Re: FCC ID H9PLA2400 Ref # 13402

Re:	FCC ID H9PLA2400	
Applicant:		Symbol Technologies Inc
Correspondence Reference Number:	13402	
731 Confirmation Number:		EA96849
Date of Original E-Mail:	04/11/2000

RF Exposure Antenna Summary

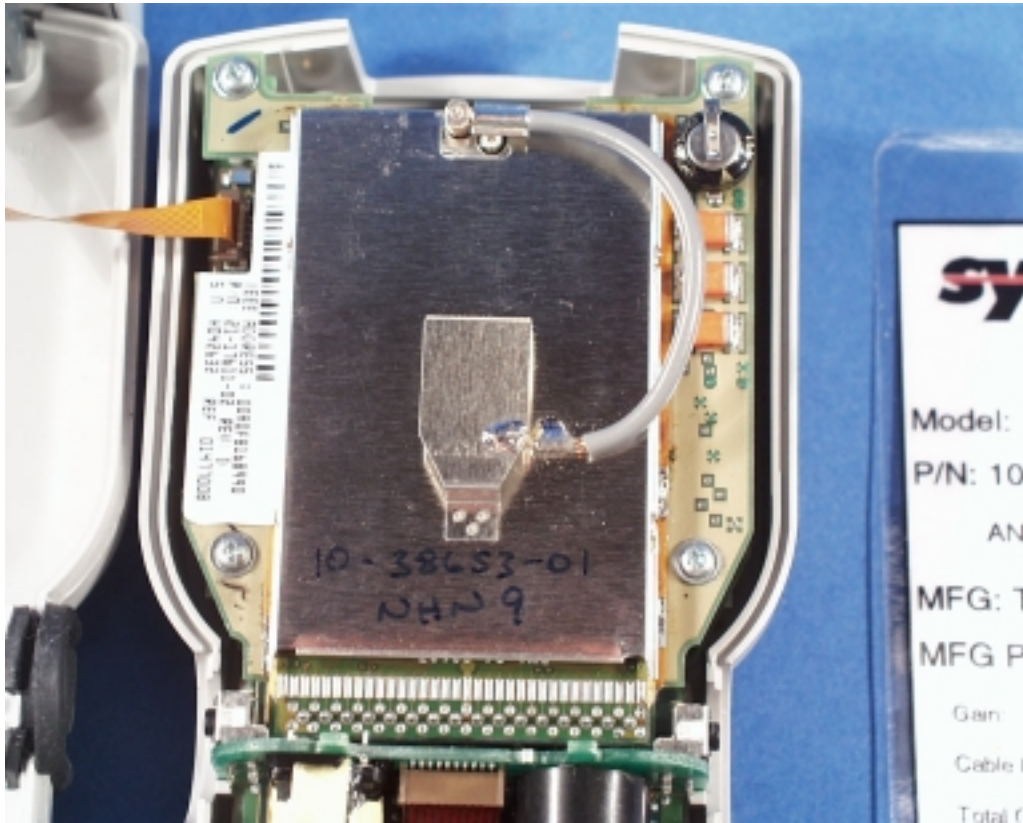
The test report indicates 5 antennas. The RF exposure info indicates 8 antennas. Only pictures of 6 antennas were submitted. Provide a correct list of antennas. For each antenna, list the type and model number and the gain. Correct the type, model number and gain in the test report, the RF exposure, antenna list. Some of the gains, model number and pictures did not agree. Please check everything.

The 9th column of the Antenna Summary table shows the TR Status (Test Report) that two antennas were withdrawn. That's why there are only 6 pictured. (8 – 2 = 6) Note that antenna number 7 says see Ant #2. I did this since per a previous email you stated that only the highest gain antenna of each type needed to be tested. Since Antenna #2 is the same type and gain as #7 I refer you to #2 for the test data of #7. I have also included with this response another antenna #9 which is listed in the corrected Antenna Summary Table and in the same way refers to Ant #2. The #9 antenna description is included in this response.

The summary table is generated from a database that has the antenna gain, cable length, type of cable and its loss characteristics. I have corrected the gain of #3 in my database to match its data sheet and attached a corrected summary table.

The correct number of desired antennas in this application is 7 = 5 + 2:
